Product Change Notification

1. ECR #: 26-46969-1
Notification #: 825

- YFS - .050 (1.27) Multi-Row Socket Assembly

Iso View: New Product (Left), compared to Existing Product (Right)

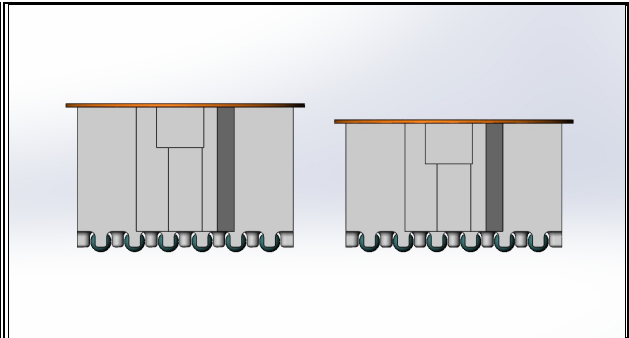
This design update is backwards compatible and extends contact wipe by .024" for all applications adhering to the standards prescribed for 12 mm stack height.

Visual - Overall height of Revision B connector is taller than Revision A connector. See graphic images.

Endview: New Product (Left), compared to Existing Product (Right)

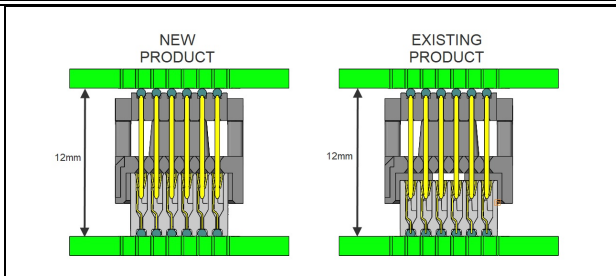
- Form - Height change of Revision B connector is visually apparent when compared to the previous revision.
- Fit - Height of Revision B connector is increased .024" over the previous revision.
